WATERBURY FILING NO. 1 & 2

GRADING, EROSION AND SEDIMENT CONTROL

OCTOBER 2022

GRADING AND EROSION CONTROL PLAN
 INITIAL EROSION CONTROL PLAN 1

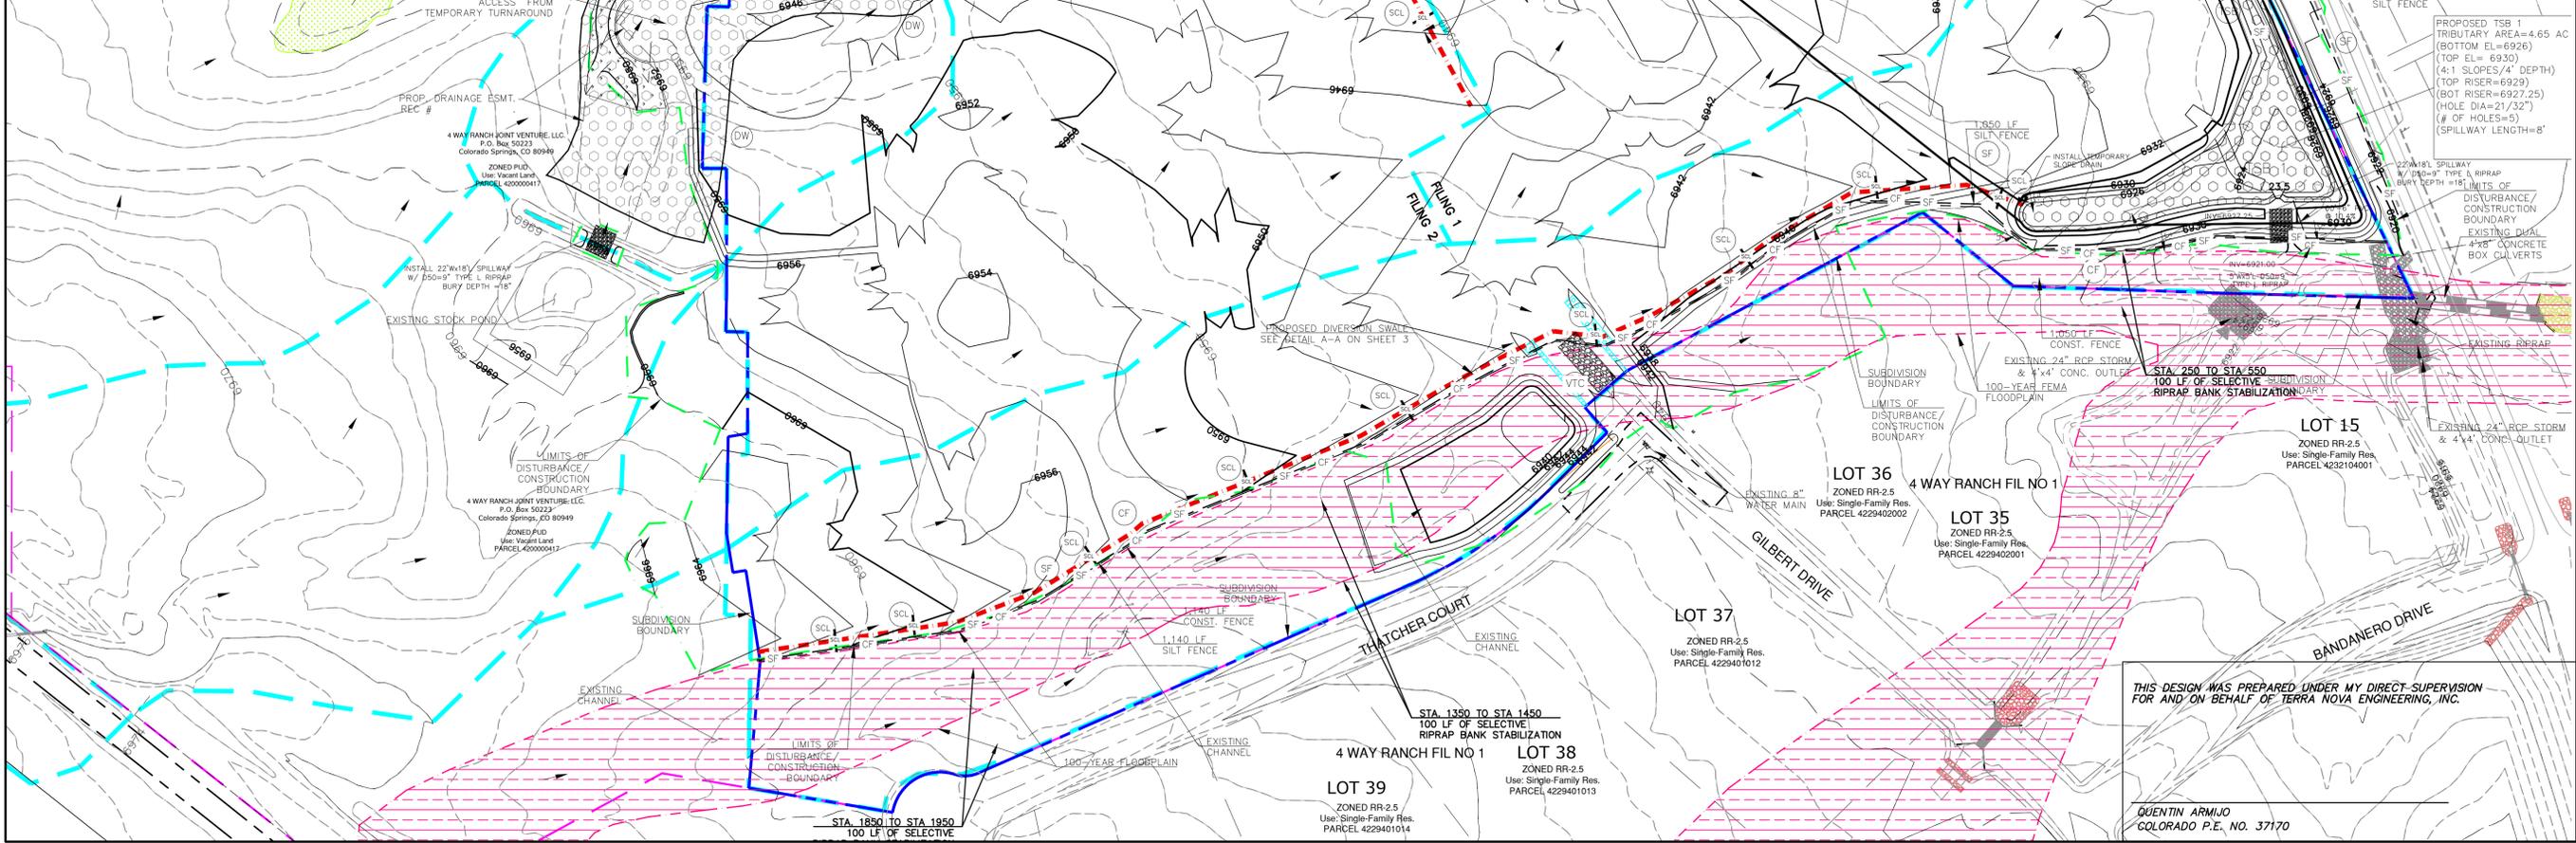
Channel BMPs?
 ADDED SILT & CONSTRUCTION FENCE ON BOTH DOWN SLOPES OF GRADING FOR CROSSING OTHER THAN THAT DON'T BELIEVE WE NEED ANY OTHER BMPs FOR CHANNEL

REVISED
 Appears to be multiple sets of grading being shown. Please only show existing and early grading

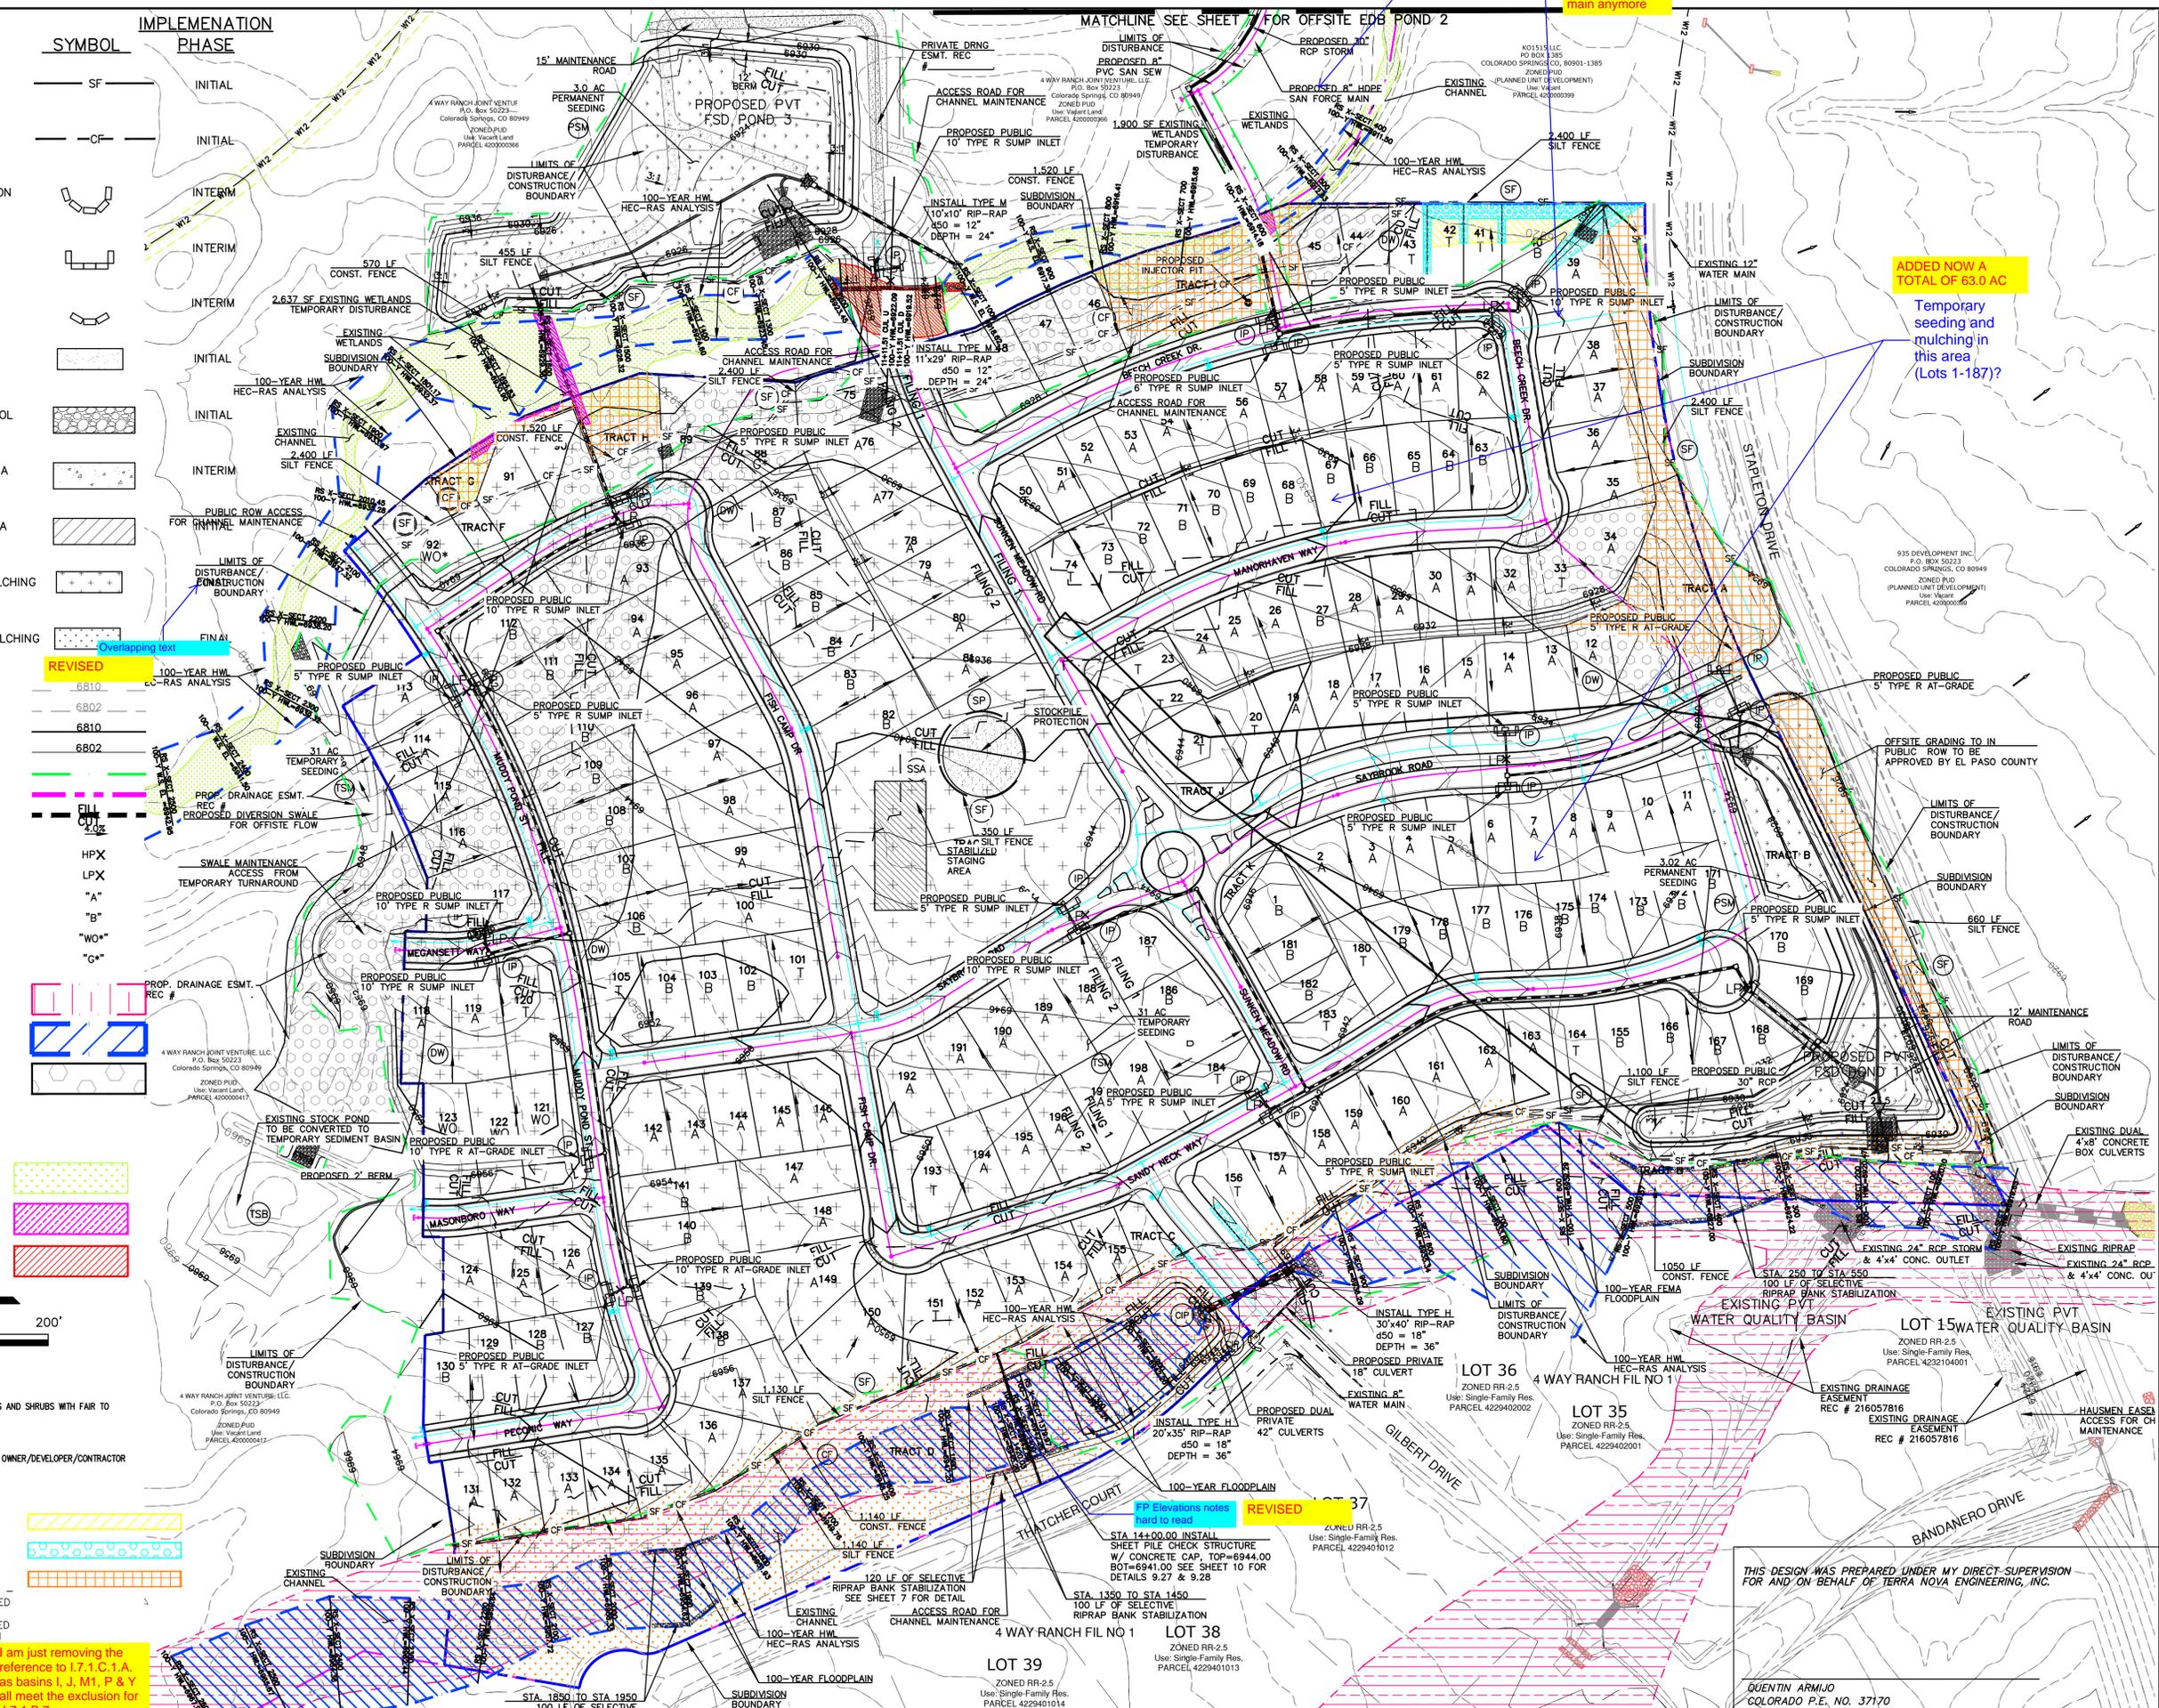
Revise text per comments on Drainage Report.

ADDED NOW A TOTAL OF 63.0 AC Temporary seeding and mulching in this area (Lots 1-187)?

I am just removing the reference to 1.7.1.C.1.A as basins I, J, M1, P & Y all meet the exclusion for 1.7.1.B.7.
